**RE: PLANNING APPLICATION 2022/0451 – LAND WEST OF MARKET STREET, EDENFIELD**

We are writing to you again on behalf of the Edenfield Community Neighbourhood Forum (ECNF), following the submission of a revised full planning application by Pegasus Group for the erection of 238 no. residential dwellings (Use Class C3) and all associated works, including new access, landscaping and public open space at the above-mentioned site.

This formal response has been prepared by SKTP to assess the additional technical submission documents for traffic and transport matters against the Planning and Highway Authorities requirements. Each technical matter is set out and discussed in detail below.

**Figure 1:** Extract from Applicant's Parking Beat Survey Data

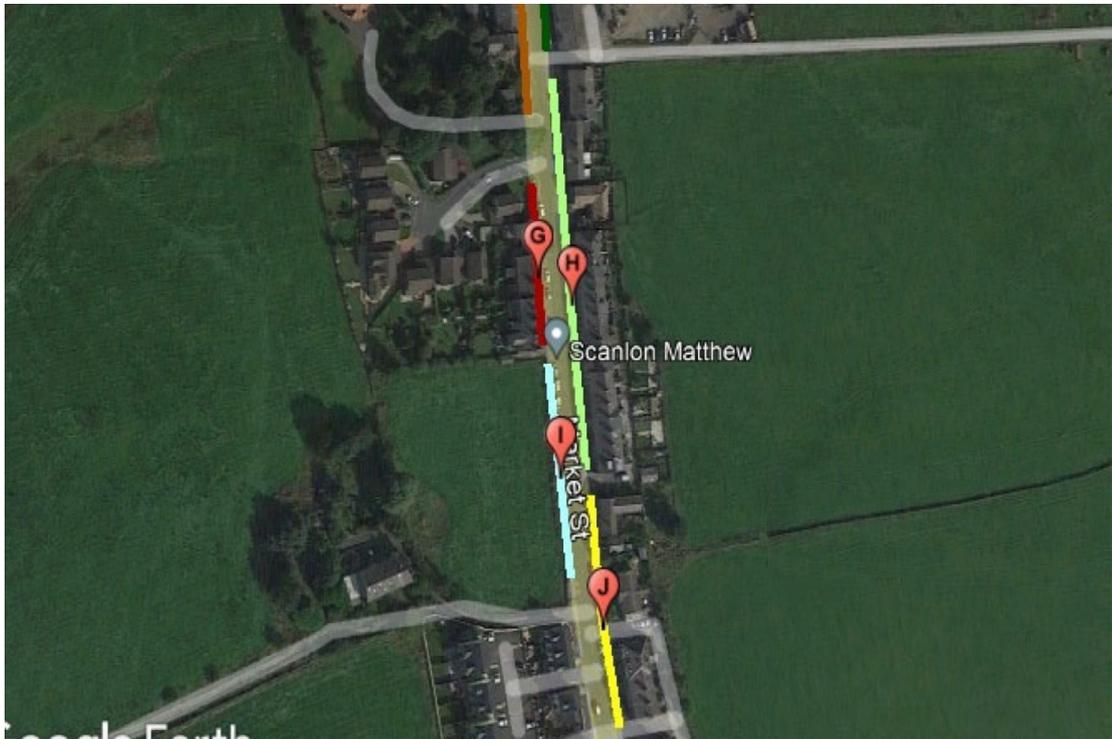
The submitted TA attempts to quantify the level of kerbside parking that takes place on this section of adopted highway and the latest parking beat surveys, undertaken between 20<sup>th</sup> and 22<sup>nd</sup> April 2023 confirm the significant volume of on-street parking that takes place on this corridor. As an example, the following on-street residential parking demand (recorded at 0730 hours on Saturday 22<sup>nd</sup> April 2023 was recorded in the following parking beat zones:

- G – 6 vehicles
- H – 20 vehicles

- I – 5 vehicles
- J – 8 vehicles

This equates to a total of 39 parked vehicles parked on-street in the immediate vicinity of the proposed main site entrance on Market Street. Applying a 6m bay space length would mean 234m of kerbside parking would be required in this location to accommodate this parking demand.

Drawing 3806-F04 H shows a formalised parking bay on the eastern side of Market Street, from No.102 to 136a. This bay measures circa 86m in length. Further south an additional bay measuring 30m is provided in front of nos. 76 to 82 Market Street. Even with this combined kerbside parking this only equates to parking for circa 19 cars, a shortfall of 20 parking spaces against the existing parking demand on this short section of Market Street.

Whilst it is noted that the applicant is now proposing a 13 space car park for Market Street residents to use, this parking provision does not even meet the shortfall calculated on this limited section of the Market Street corridor.

Based on the above we request that the applicant confirms the following information, so an informed decision can be made on the impacts of the proposed main access to the development, and the impacts on parking for existing residents on this corridor. This review should confirm:

- the existing legal kerbside parking areas along the corridor (by length)
- the current parking demand in each of these parking areas (by vehicle)
- the proposed kerbside parking bay areas along the corridor (by length)
- the net surplus/shortfall in kerbside parking generated by the access proposals and required TROs

**Figure 2:** Extract from Applicant's Corridor Improvement Strategy

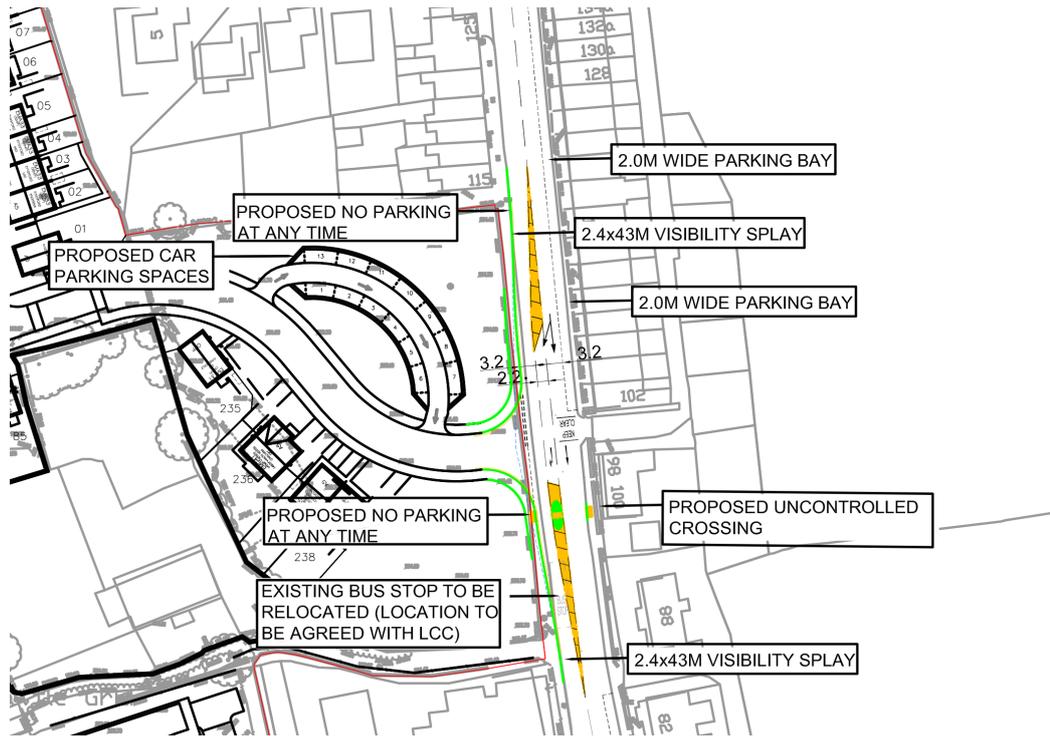
As shown in **figure 2** below the proposed design does not meet the design requirements set out above for the width of the ghosted right turn lane. Paragraph 6.10 confirms 3m is the minimum width for a new junction, and is required to ensure a motorist can safely wait whilst turning right clear of oncoming traffic and to avoid vehicles blocking southbound ahead movements.

A 2.2m wide right turn pocket does not meet the requirements of CD123. It is 0.8m narrower than the minimum 3m wide pocket for a new junction.

In addition, with the access proposals not delivering a 2m wide footway on the eastern side of Market Street, the design as proposed cannot be considered appropriate to serve a new residential development of any scale.

We believe the reason why the applicant has chosen not to present an access design that complies with CD123 and shows the widened 2m footway on the eastern side of Market Street, the 2m wide parking bay and a 3m wide right turn pocket width is because this cannot be physically accommodated along the site frontage.

This matter was raised during the EiP discussions, in our original submissions to the planning application and are now presented again. It is essential that at some point during the life of the application the applicant confirms whether a CD123 compliant access scheme can be delivered on Market Street.
